Going-to-the-Sun Road
Identified Roadway Deficiencies - 2001

Going-to-the-Sun Road
Identified Roadway Deficiencies - 2001
Alpine Section
Alder Creek Segment - Map 1 of 3
Guard Walls:
ashlar stone
concrete-core
jersey barrier
removable rail
random rubble stone
mixed stone
Retaining Walls:
concrete
stone
Other Linear Features:
barrier rock
curb
post and rail fence
CMP culvert with stone headwall
concrete-box cross-road drains with metal grate inlet
CMP culvert
CMP culvert with stone headwall
CMP culvert with modern drop box inlet
CMP culvert with stone headwall
CMP culvert with stone headwall
drop inlet covered with boards
FHWA wall 25.01
FHWA wall 25.29
FHWA wall 25.32
FHWA wall 25.33
FHWA wall 25.34
FHWA wall 25.36
FHWA wall 22.82
pullout
pullout
pullout
MP 23.0
MP 23.1
MP 25.3
MP 25.4
MP 25.5
MP 25.6
MP 25.7
919
917
916
915
914
913
912
911
910
909
908
906
905
904
903
MP 25.3 - 25.5:

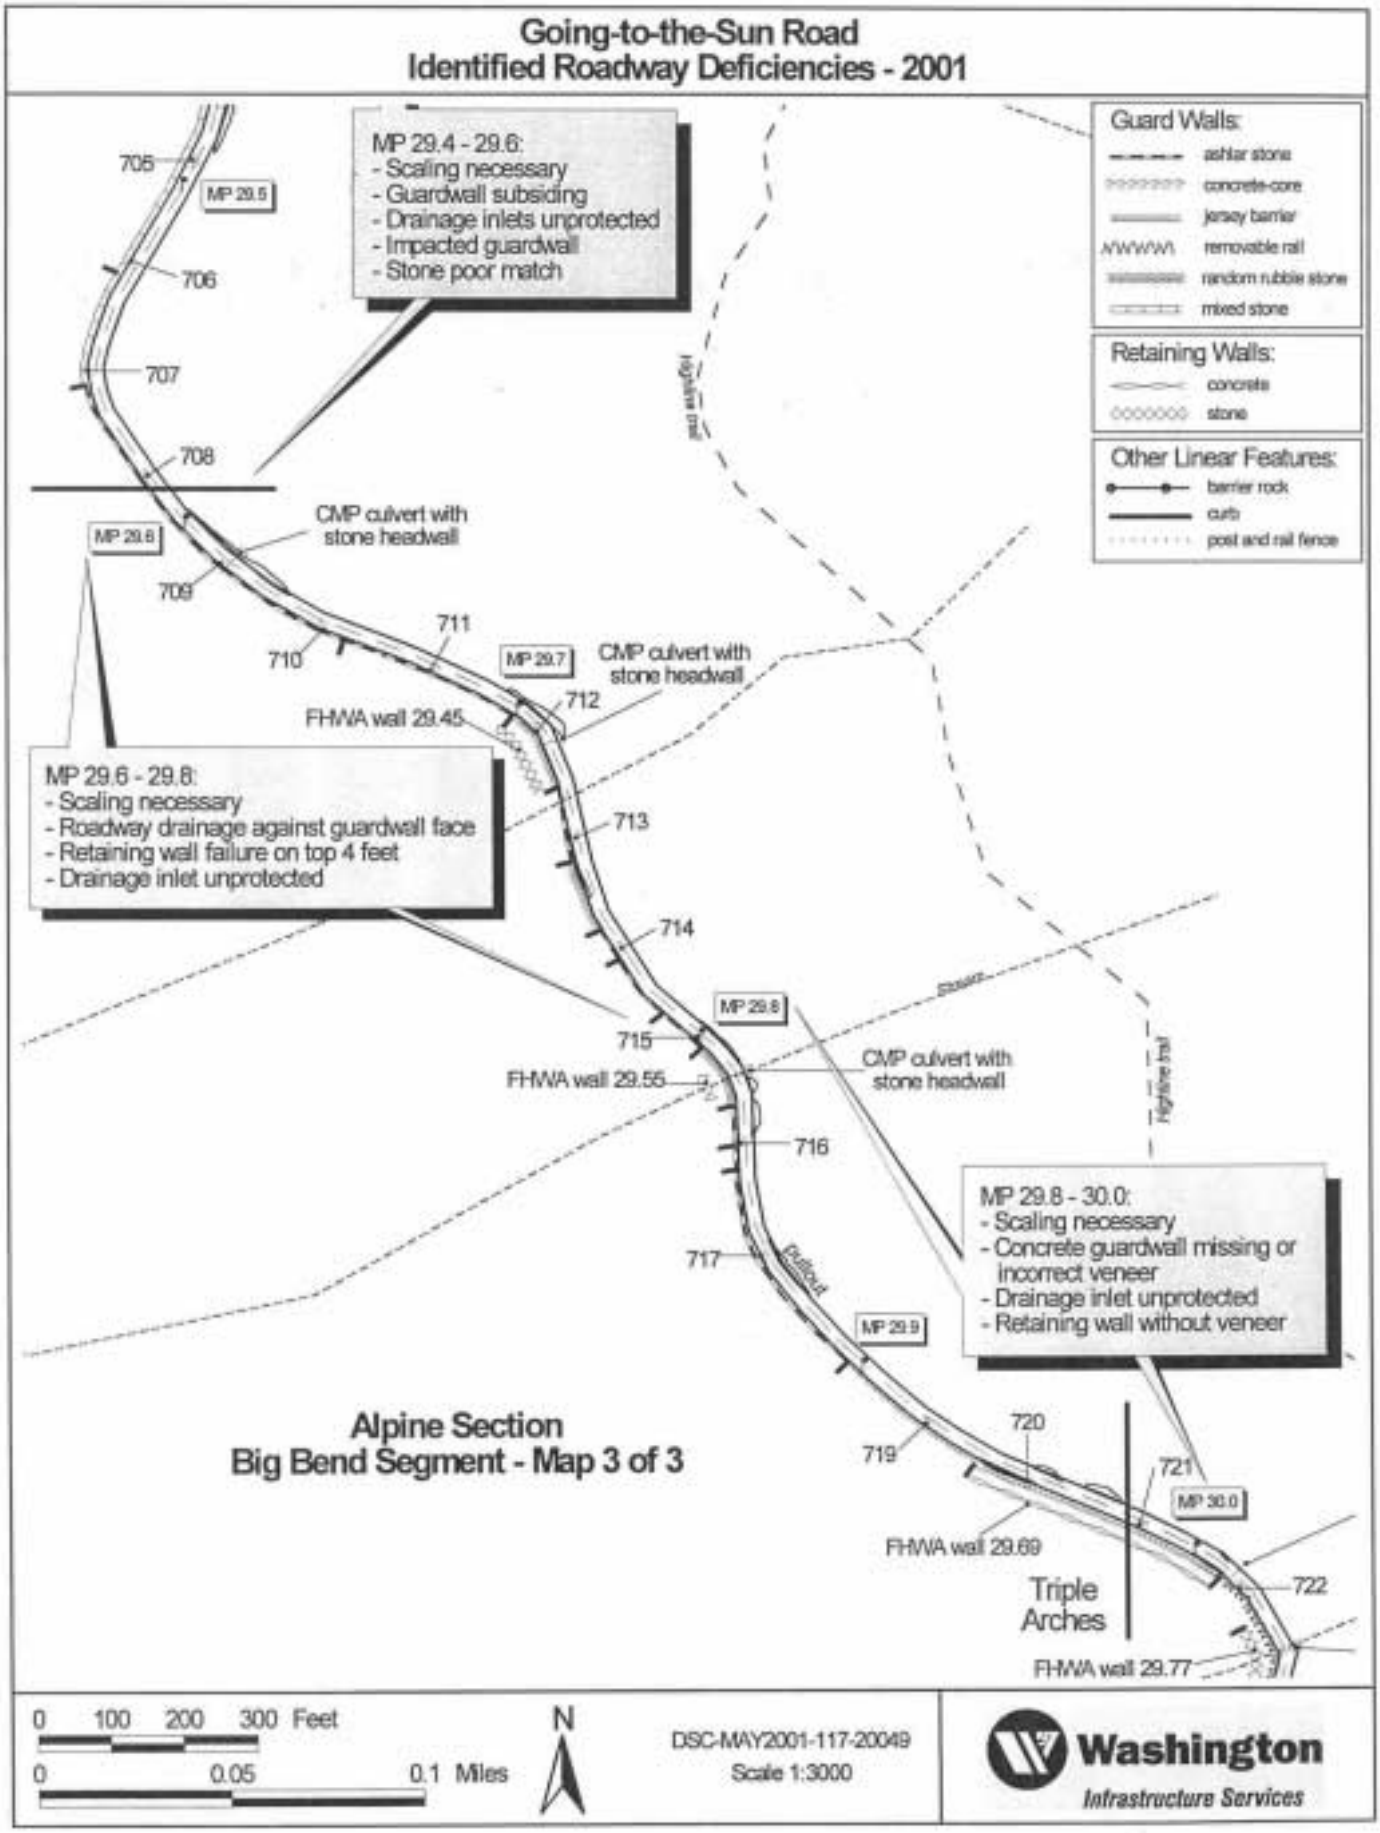
Going-to-the-Sun Road
Identified Roadway Deficiencies - 2001
MP 29.4 - 29.6:
- Scaling necessary
- Guardwall subsiding
- Drainage inlets unprotected
- Impacted guardwall

- Stone poor match
MP 29.6 - 29.8:
- Scaling necessary
- Roadway drainage against guardwall face
- Retaining wall failure on top 4 feet
- Drainage inlet unprotected
MP 29.8 - 30.0:

- Scaling necessary
- Concrete guardwall missing or incorrect veneer
- Drainage inlet unprotected
- Retaining wall without veneer
Guard Walls:
ashlar stone
concrete-core
jersey barrier
removable rail
random rubble stone
mixed stone
Retaining Walls:
concrete
stone
Other Linear Features:
barrier rock
curb
post and rail fence
CMP culvert with stone headwall
FHWA wall 29.45
FHWA wall 29.55
FHWA wall 29.69
FHWA wall 29.77
Triple Arches
Highline trail
Pullout
MP 29.5
MP 29.6
MP 29.7
MP 29.8
MP 29.9
MP 30.0
705
706
707
708
709
710
711
712
713
714
715
716
717
719
720
721
722
Alpine Section
Big Bend Segment - Map 3 of 3
0 100 200 300 Feet
0 0.05 0.1 Miles
N
DSC-MAY2001-117-20049
Scale 1:3000
Washington
Infrastructure Services

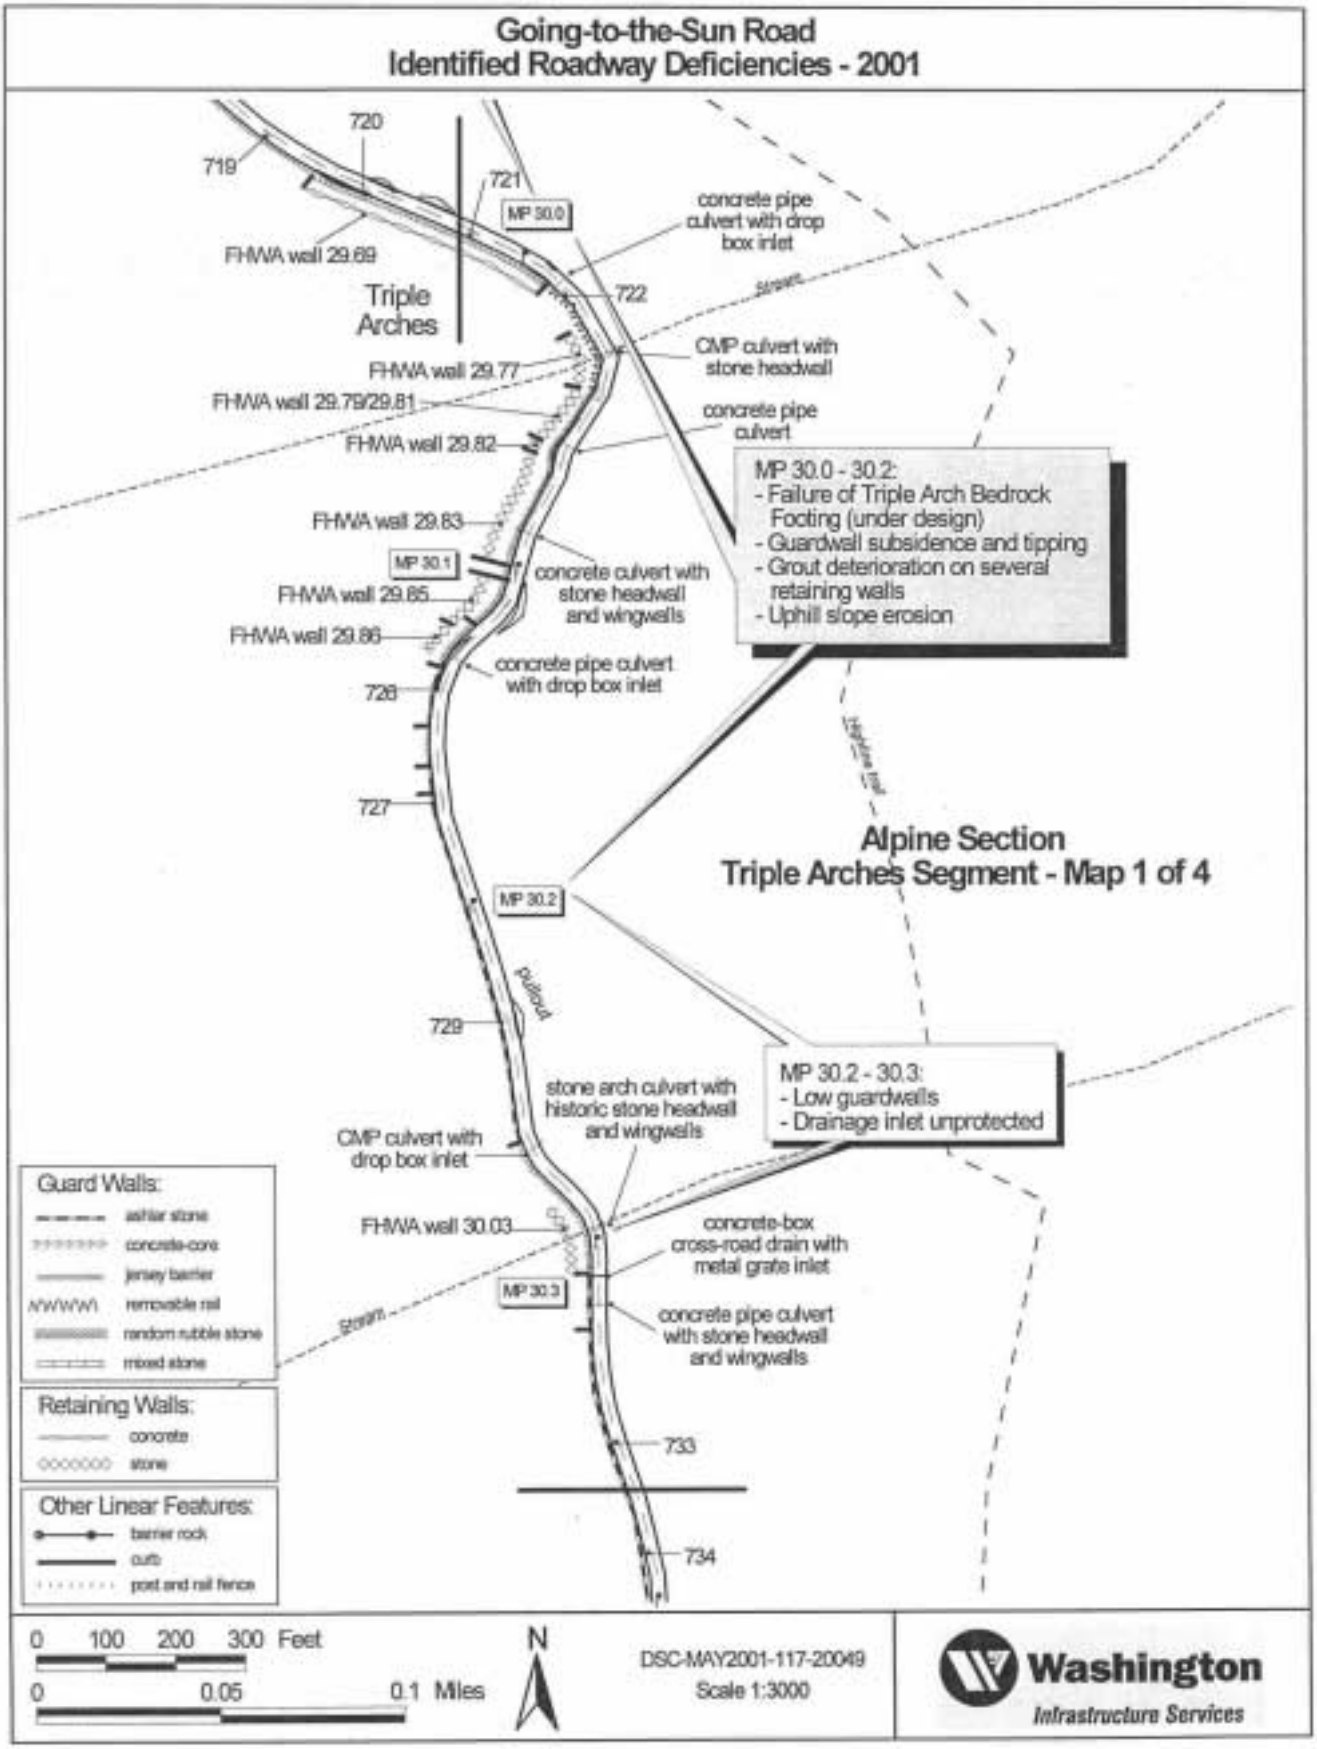
- Failure of Triple Arch Bedrock Footing (under design)
- Guardwall subsidence and tipping
- Grout deterioration on several retaining walls
- Uphill slope erosion
FHWA wall 29.83
MP 30.1
FHWA wall 29.85
FHWA wall 29.86
concrete culvert with stone headwall and wingwalls
concrete pipe culvert with drop box inlet
728
727
Alpine Section
Triple Arches Segment - Map 1 of 4
MP 30.2
729
MP 30.2 - 30.3:

- Low guardwalls
- Drainage inlet unprotected
stone arch culvert with historic stone headwall and wingwalls
CMP culvert with drop box inlet
FHWA wall 30.03
concrete-box cross-road drain with metal grate inlet
MP 30.3
concrete pipe culvert with stone headwall and wingwalls
733
734
Guard Walls:
ashlar stone
concrete-core
jersey barrier
removable rail
random rubble stone
mixed stone
Retaining Walls:
concrete
stone
Other Linear Features:
barrier rock
curb
post and rail fence
0 100 200 300 Feet
0 0.05 0.1 Miles
N
DSC-MAY2001-117-20049
Scale 1:3000
Washington
Infrastructure Services

- Guardwalls subsiding and tipping
- Minor drainage repairs
Alpine Section
Triple Arches Segment - Map 2 of 4
Highline Trail
Stream
Stream
0 100 200 300 Feet
0 0.05 0.1 Miles
N
DSC-MAY2001-117-20049
Scale 1:3000
Washington
Infrastructure Services

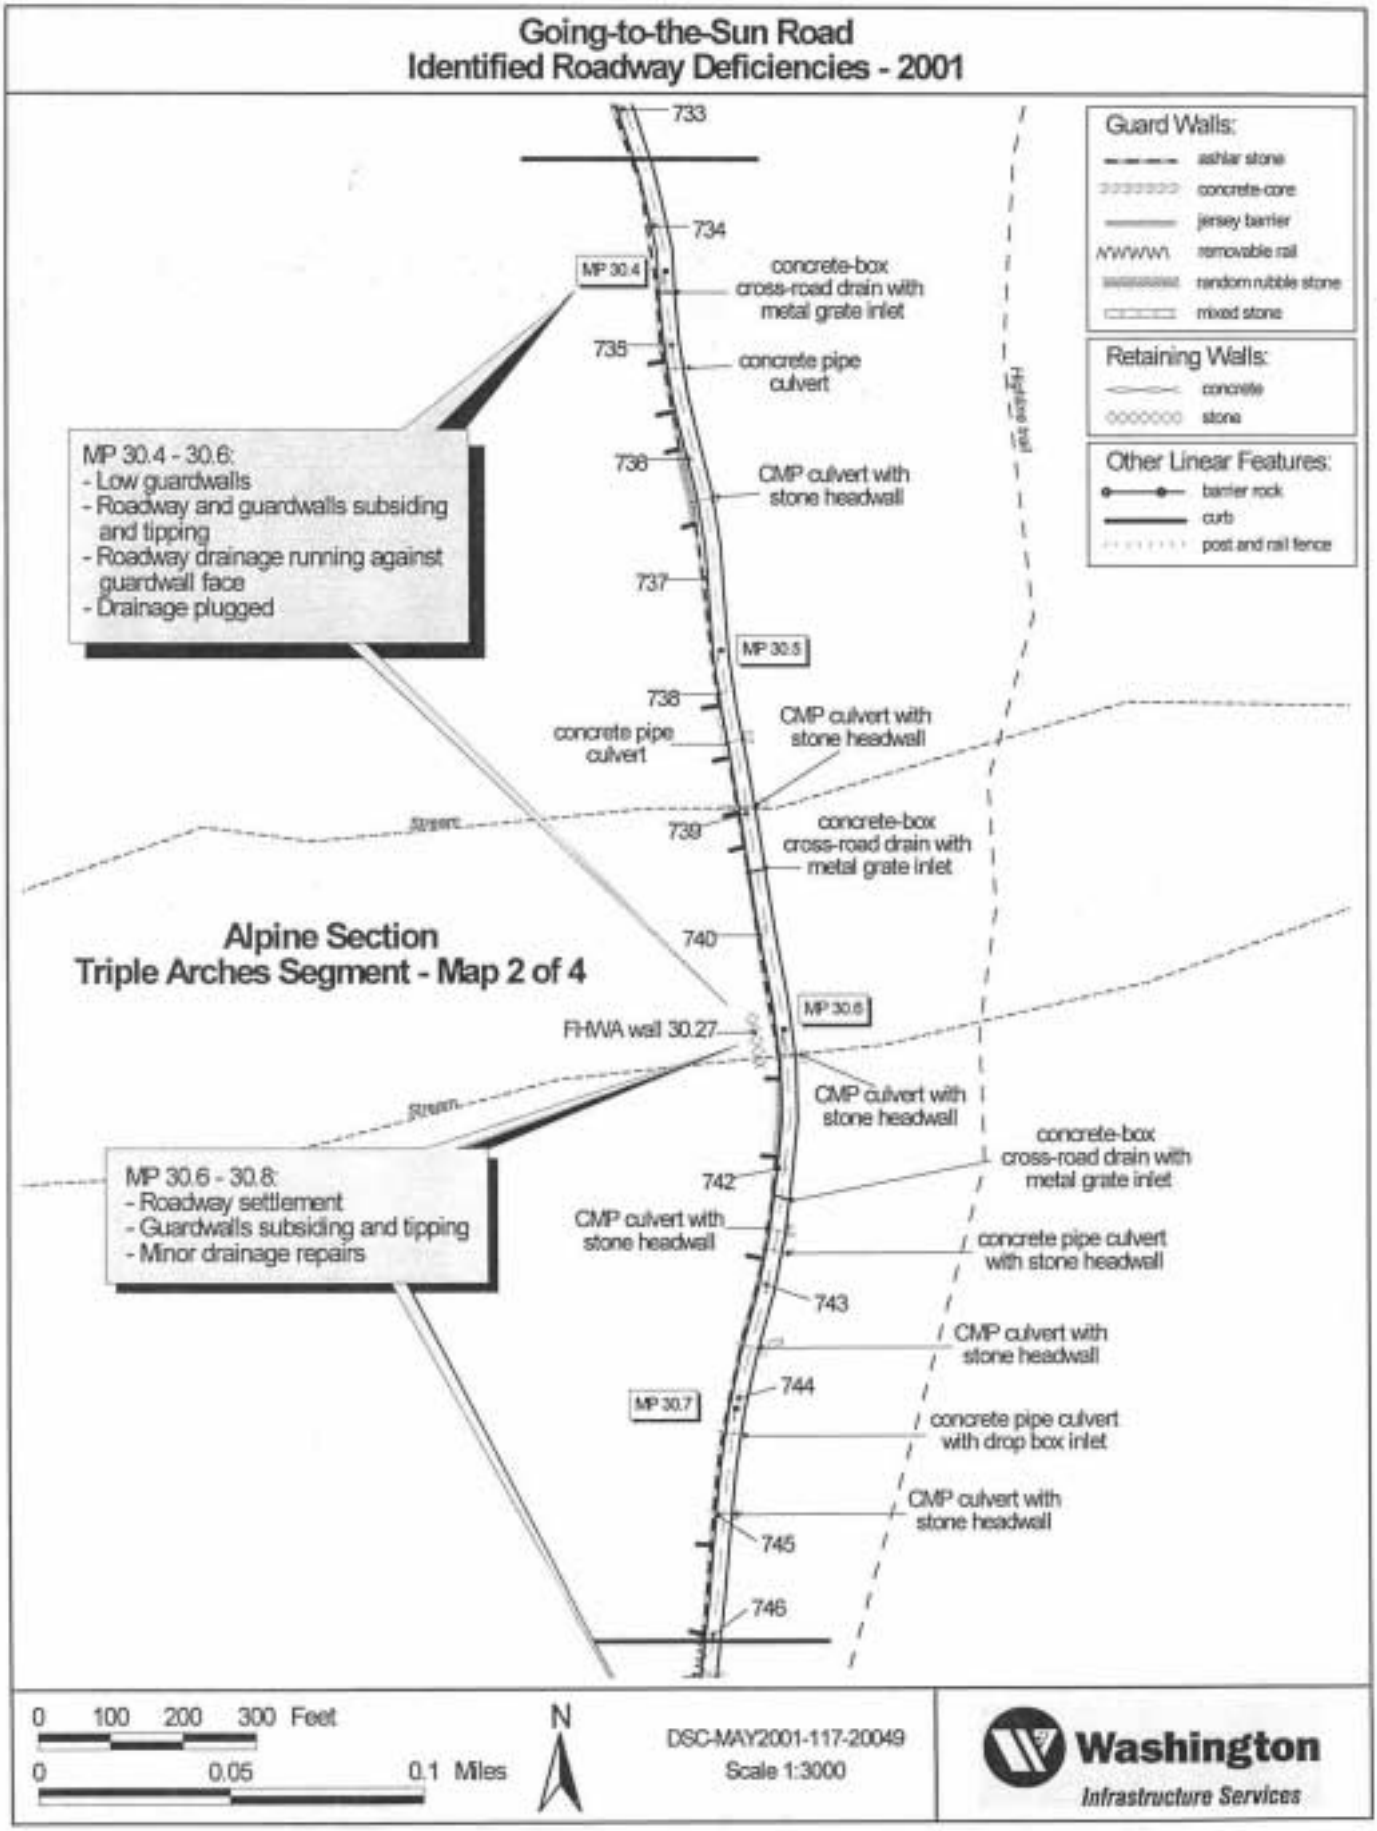
- Low guardwalls
- Roadway and guardwalls subsiding and tipping
- Roadway drainage running against guardwall face
- Drainage plugged
MP 30.6 - 30.8:
- Roadway settlement

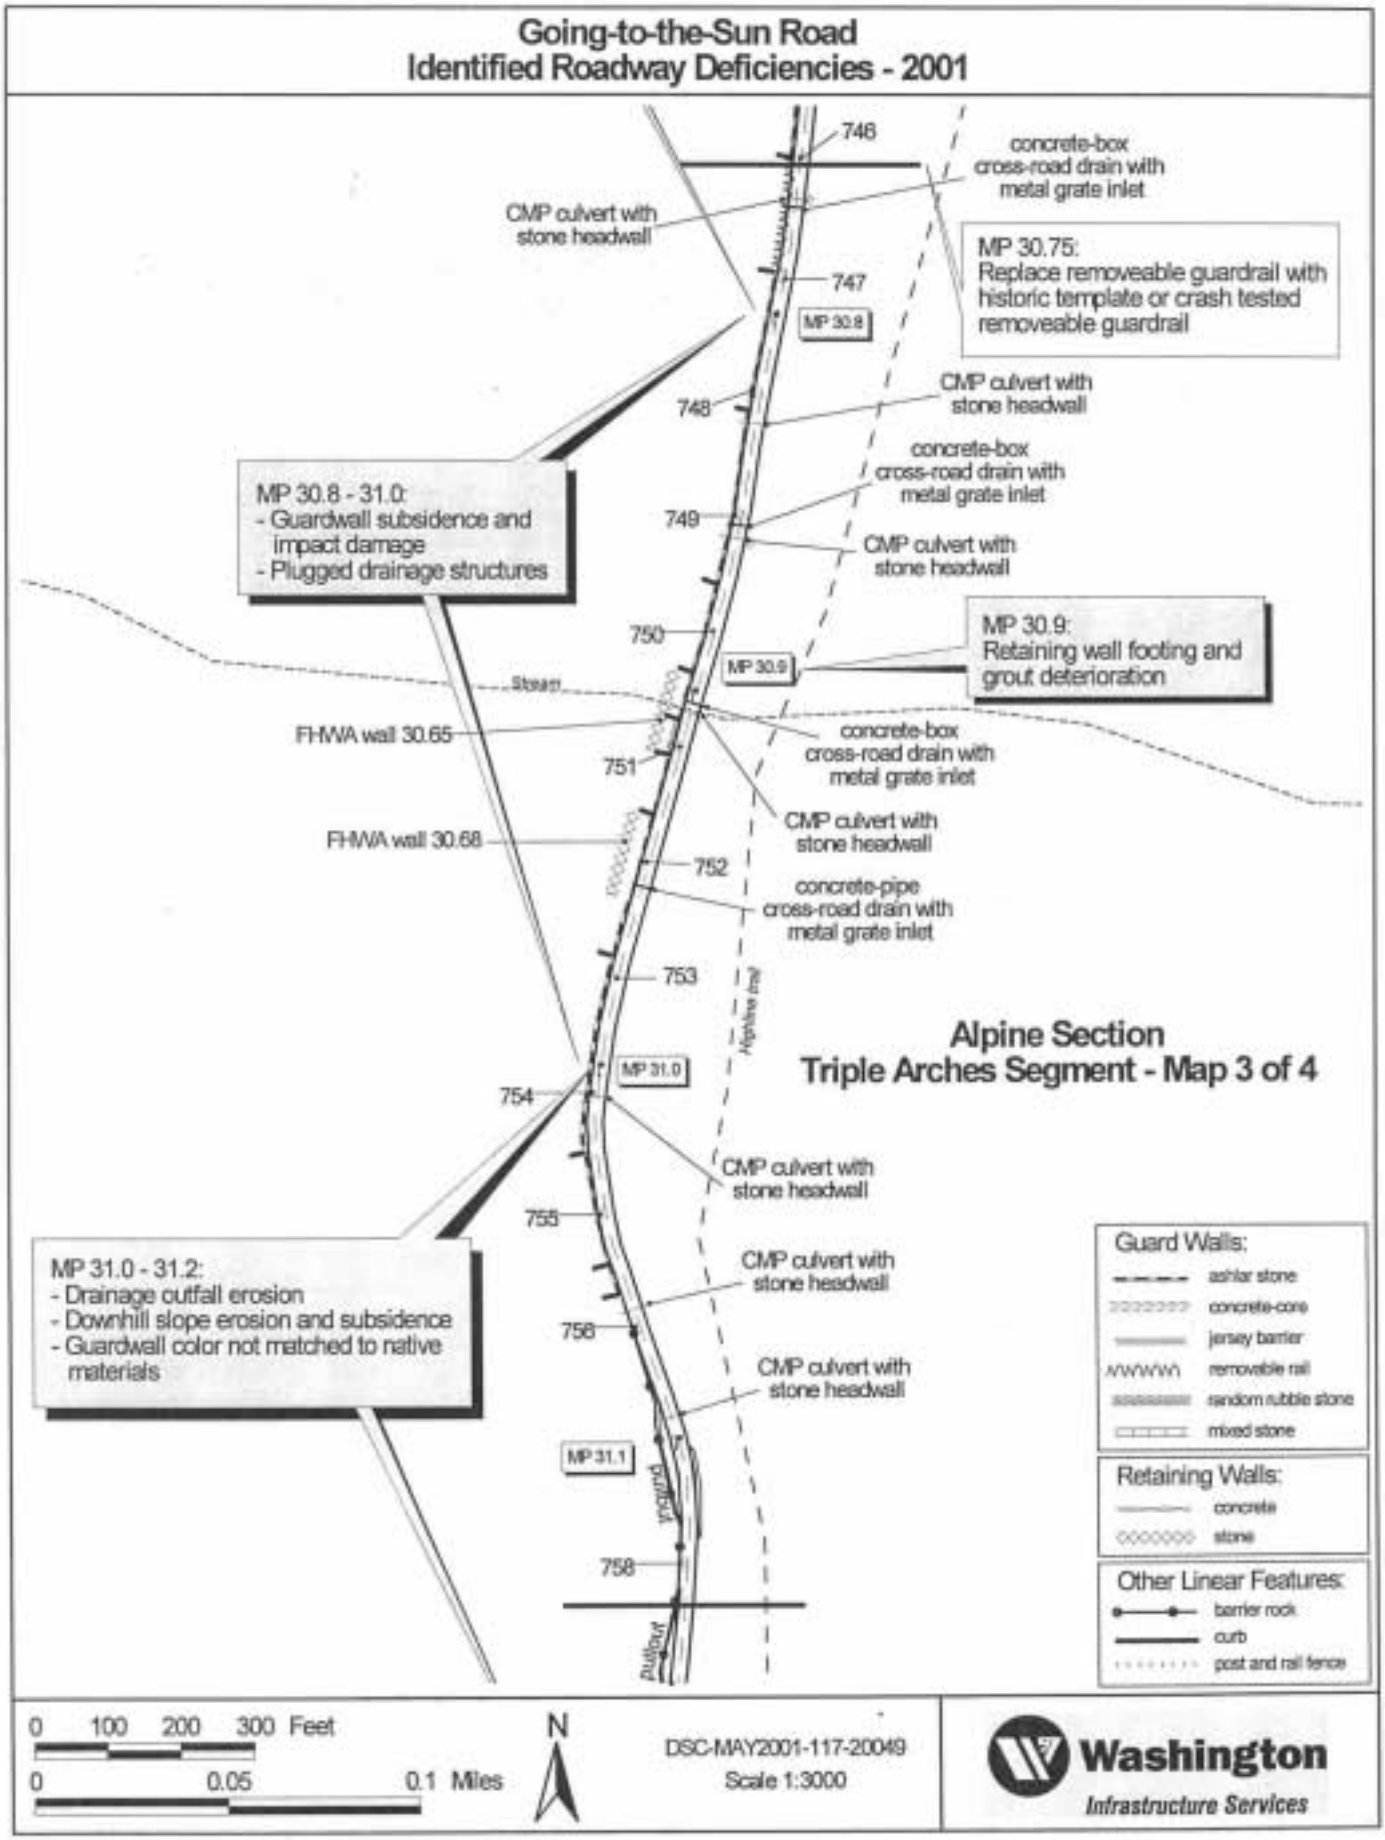
Going-to-the-Sun Road
Identified Roadway Deficiencies - 2001
746
concrete-box cross-road drain with metal grate inlet
CMP culvert with stone headwall
MP 30.75:
Replace removeable guardrail with historic template or crash tested removeable guardrail
747
MP 30.8
CMP culvert with stone headwall
748
concrete-box cross-road drain with metal grate inlet
MP 30.8 - 31.0:

- Guardwall subsidence and impact damage
- Plugged drainage structures
749
CMP culvert with stone headwall
750
MP 30.9
MP 30.9:
Retaining wall footing and grout deterioration
Stream
FHWA wall 30.65
concrete-box cross-road drain with metal grate inlet
751
CMP culvert with stone headwall
FHWA wall 30.68
752
concrete-pipe cross-road drain with metal grate inlet
753
Alpine trail
Alpine Section
Triple Arches Segment - Map 3 of 4
MP 31.0
754
CMP culvert with stone headwall
755
CMP culvert with stone headwall
MP 31.0 - 31.2:

- Drainage outfall erosion
- Downhill slope erosion and subsidence
- Guardwall color not matched to native materials
756
CMP culvert with stone headwall
MP 31.1
Pullout
758
Pullout
Guard Walls:
ashlar stone
concrete-core
jersey barrier
removable rail
random rubble stone
mixed stone
Retaining Walls:
concrete
stone
Other Linear Features:
barrier rock
curb
post and rail fence
0 100 200 300 Feet
0 0.05 0.1 Miles
N
DSC-MAY2001-117-20049
Scale 1:3000
Washington
Infrastructure Services
